U.S. Department
of Transportation
**Pipeline and Hazardous
Materials Safety
Administration**

Reference No. 19-0025R

This letter is in response to your March 4, 2019 email and a meeting on May 19, 2025, with members of the Standards and Rulemaking Division, requesting clarification of the Hazardous Materials Regulations (HMR; 49 CFR Parts 171-180) applicable to the transportation of propane in a specification MC 331 cargo tank motor vehicle (bobtail). After further review, Reference No. 19-0025 has been superseded by this revised letter.

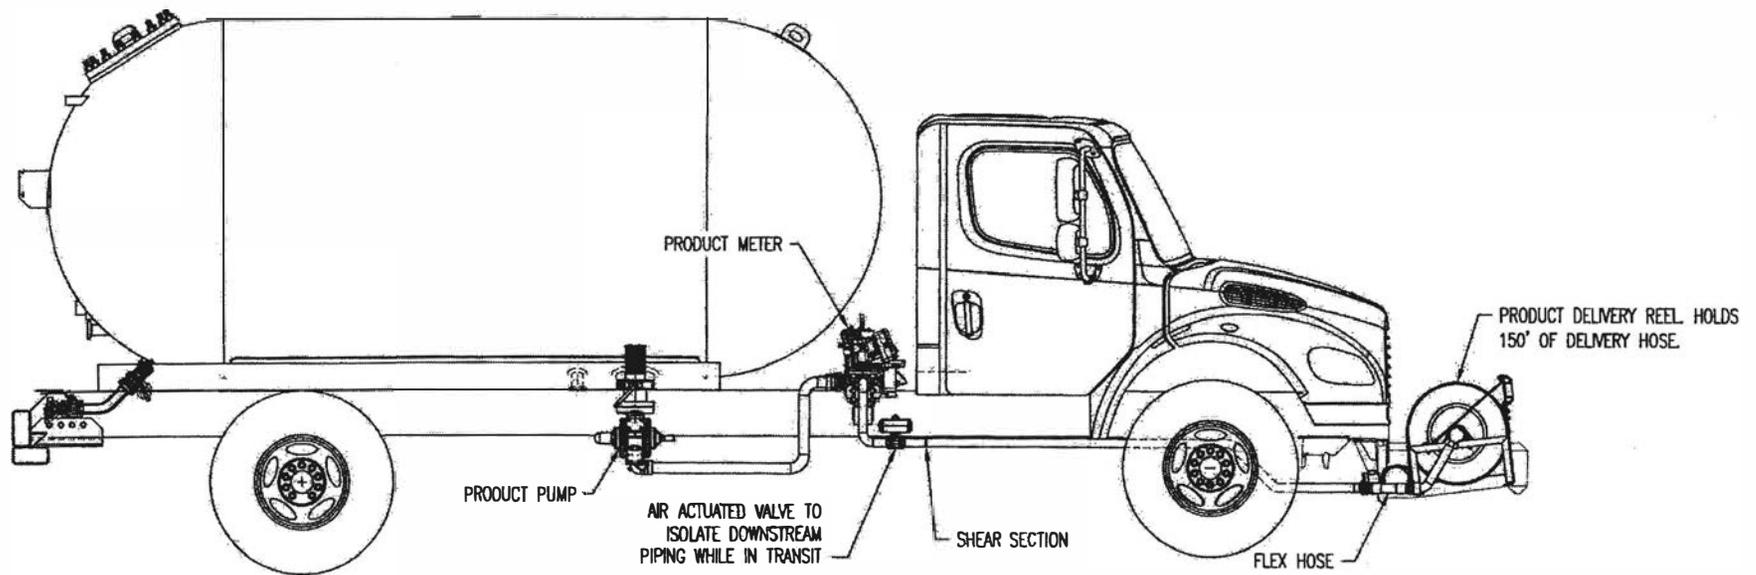
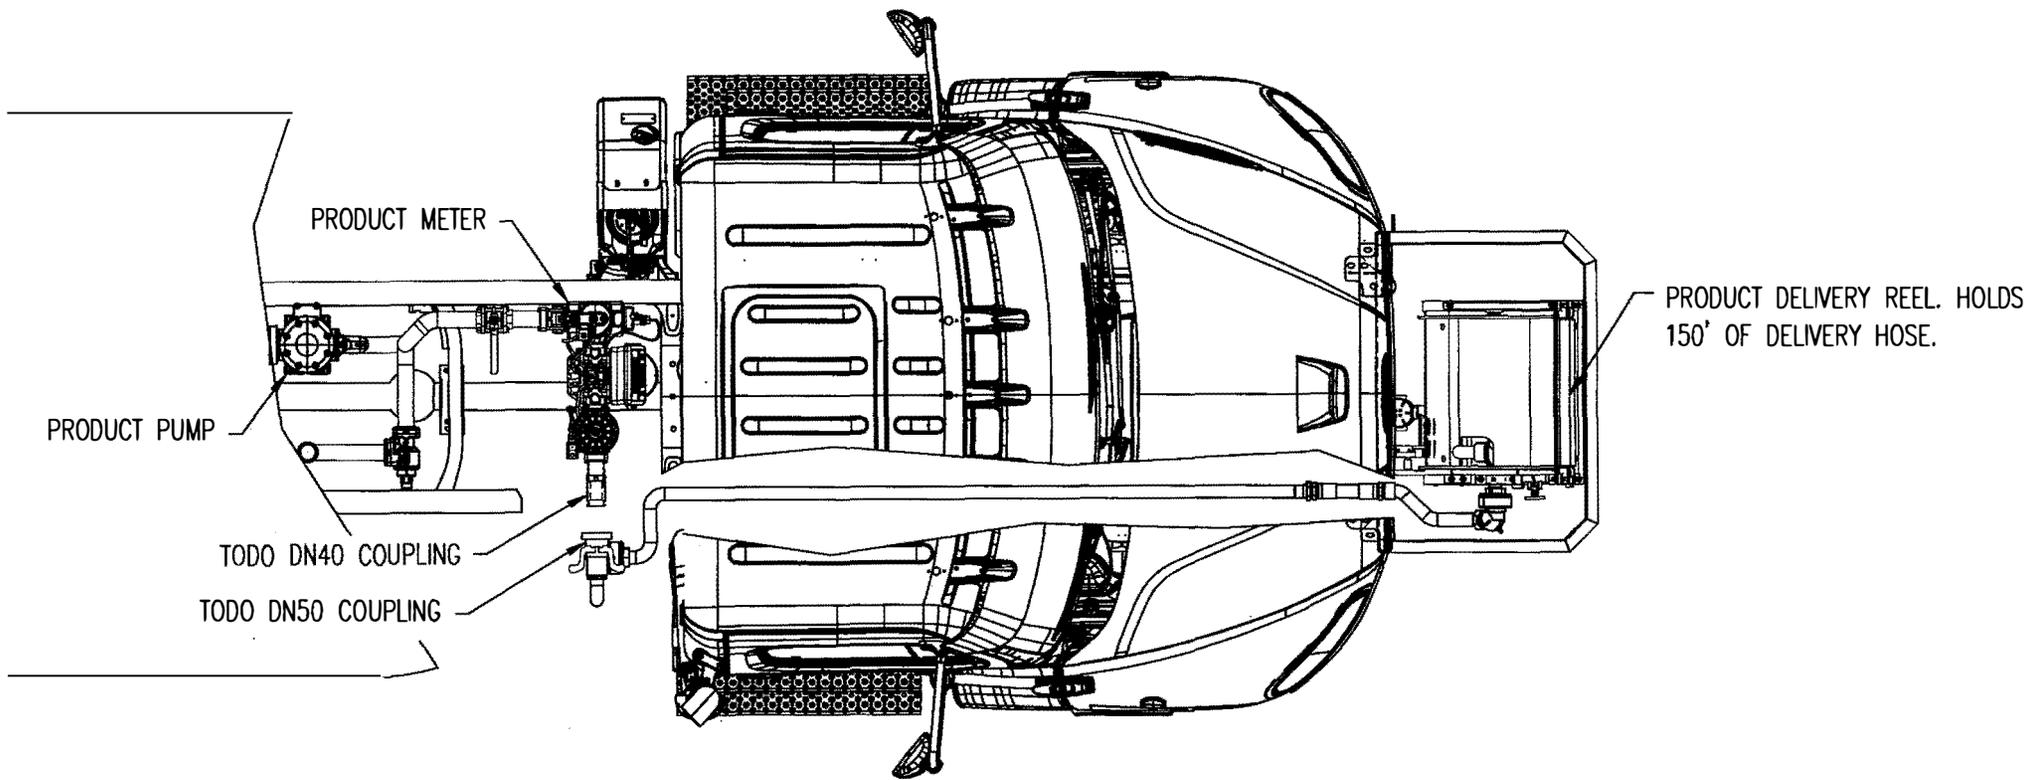
You describe a scenario where propane deliveries require drivers to reverse into unfamiliar locations to complete the delivery of propane to customers. This presents safety concerns due to limited visibility and blind spots. As such, you are considering mounting a reel to the front of the bobtail chassis. Furthermore, you state that due to variations in chassis design or lack of structural support at the front of the bobtail chassis, you want to avoid installing a protection device. Based on the design drawing that was submitted, is the proposed configuration allowed by the HMR?

13' OF 1.5 PIPING = 1.37 GALLONS
150' OF 1" HOSE = 6.12 GALLONS
PRODUCT IN REEL = 1 GALLONS

THERE WILL BE UP TO 10 GALLONS OF LIQUID PETROLEUM DOWN STREAM OF THE ISOLATION VALVE IN THE PIPING AND DELIVERY HOSE

THERE WILL BE UP TO 10 GALLONS OF LIQUID PETROLEUM DOWN STREAM OF THE DRY BREAK COUPLER IN THE PIPING AND DELIVERY HOSE

No. While there is not a restriction against mounting the hose reel and piping to the front of the MC 331 chassis, § 178.337-10(a) requires “[a]ll valves, fittings, pressure relief devices, and other accessories to the tank proper shall be protected in accordance with paragraph (b) of this section against such damage as could be caused by collision with other vehicles or objects. . .” Furthermore, in accordance with § 178.337-10(f)(2), each internal self-closing stop valve, excess flow valve, and check valve must be shielded by a shear section or other sacrificial device.

This protection device must be placed in the piping system outboard of the stop valve and within the accident damage protection device to prevent any accidental loss of lading. Based on the information and attachments provided, your design would not meet the accident damage protection requirements prescribed in § 178.337-10.
